HISTORIC AND DESIGN REVIEW COMMISSION

Agenda Item No: 15

HDRC CASE NO: 2016-172
ADDRESS: 283 W MARIPOSA
LEGAL DESCRIPTION: NCB 9012 BLK 6 LOT 89 90 AND W 12.50 FT OF 88
ZONING: R4 H
CITY COUNCIL DIST.: 1
DISTRICT: Olmos Park Terrace Historic District
APPLICANT: Edward Pape
OWNER: Christine Catsifas
TYPE OF WORK: Expand driveway, replace garage door
REQUEST:

CATSIFAS RESIDENCE
283 W. MARIPOSA
DRAWING NOT TO SCALE

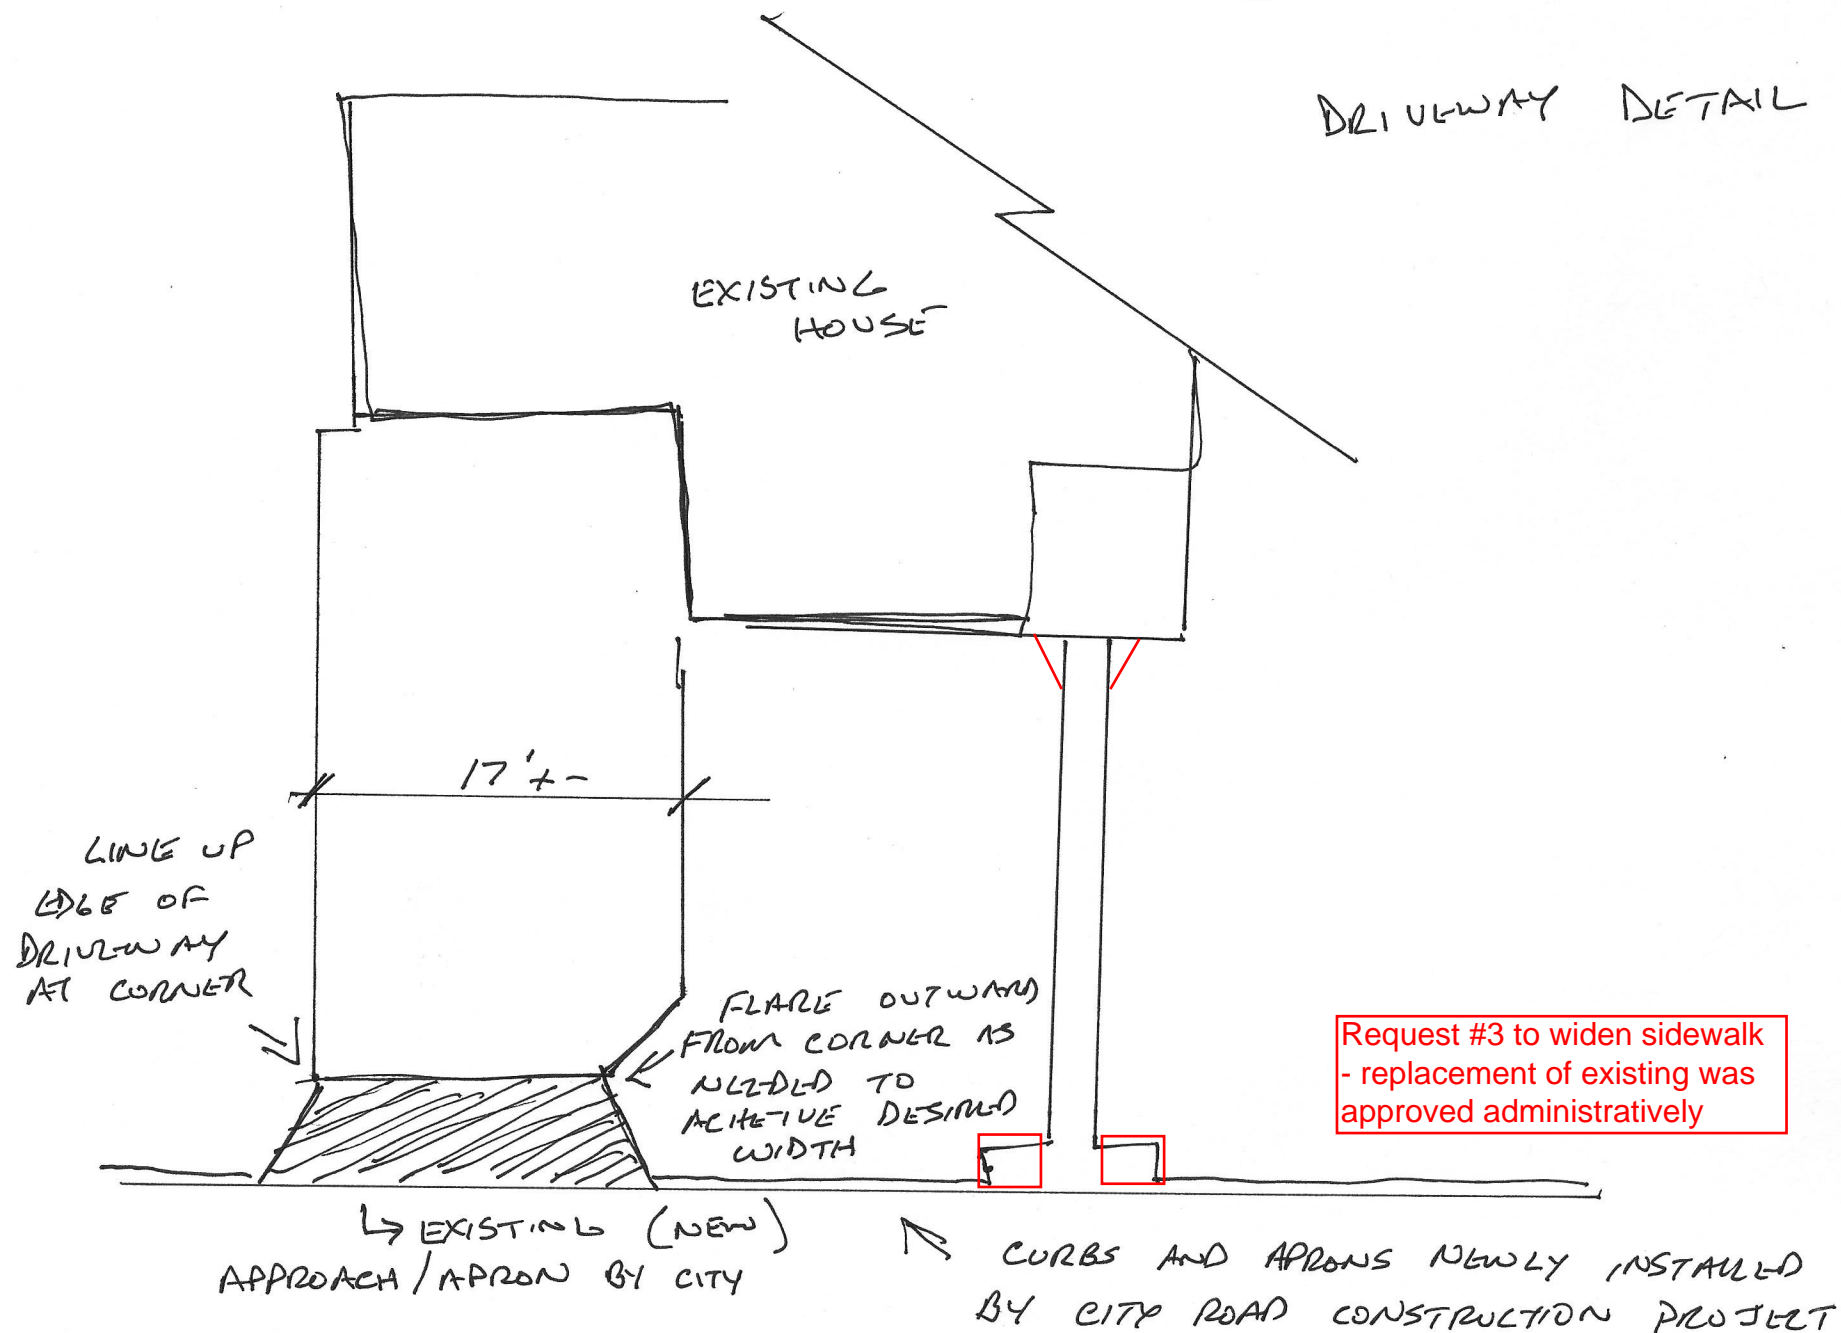
- b. The applicant is requesting to replace existing 8' x 6'-6" wooden swinging garage door with an 8' x 8' overhead metal garage door with decorative elements and trim, and to paint to match existing color. Staff finds the door appropriate in size and architecturally detailing, but finds the material inconsistent with the Guidelines. The Guidelines for Exterior Maintenance and Alteration 6.B. state that doors should be replaced with in-kind materials.

COMMENTS/CONCERNS: TC: Is there any siding
on house currently. Include trim on a sketch
w photo of front gable - made suggestions
for how to resemble carriage style existing
door. EG: It's an addition

TC: Needs more than just standard raised panels

Staff recommends denial of item #1, #2 and #3 based on findings a through d. Staff recommends that the door be replaced with in-kind materials, the applicant maintain the linear dimension and width of the driveway, and consider widening with permeable material.

PLOT PLAN

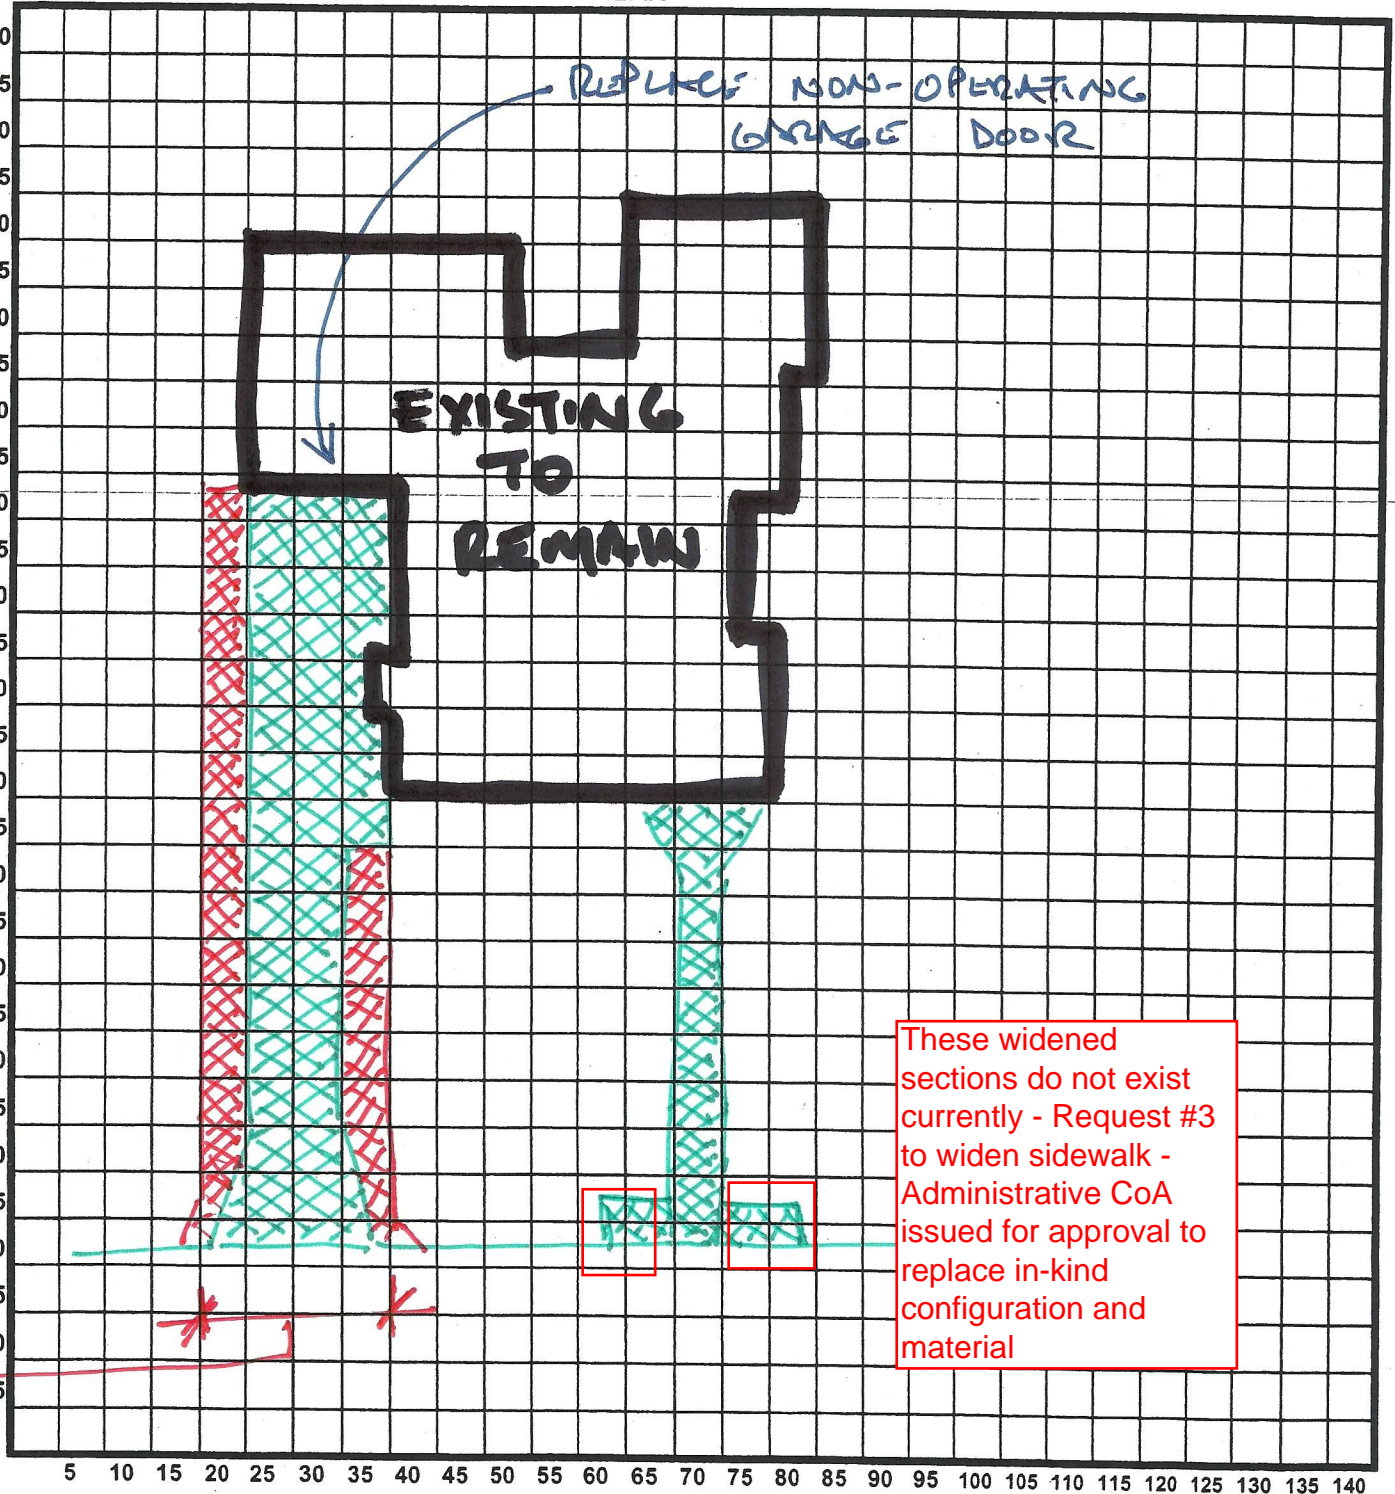
- c. The applicant is proposing to tear up existing 10' concrete driveway and repour a 17' wide concrete driveway and maintain the 12' apron, which is not consistent with the Guidelines for Site elements. The Guidelines state that historic driveways are typically no wider than 10' and that new driveway configurations should be similar to what's historically found in the district. Staff made a site visit on May 6, 2016, and found that driveways in Olmos Park Terrace Historic District historically are 10' wide. The Guidelines for Site Elements 5.B.i. also states that pervious paving surfaces may be considered when replacement is necessary. Staff recommends that the applicant maintain the historic driveway configuration and width and consider using a pervious material such as decomposed granite.

- d. The applicant is proposing to widen the sidewalk near the curb. The applicant has not yet provided staff with specific dimensions. Guidelines for the Site Elements 5.A.iii. state that historic alignment, configuration, and width of sidewalks and walkways should be followed. Staff finds the proposal inconsistent with the Guidelines.

These widened sections do not exist currently - Request #3 to widen sidewalk - Administrative CoA issued for approval to replace in-kind configuration and material
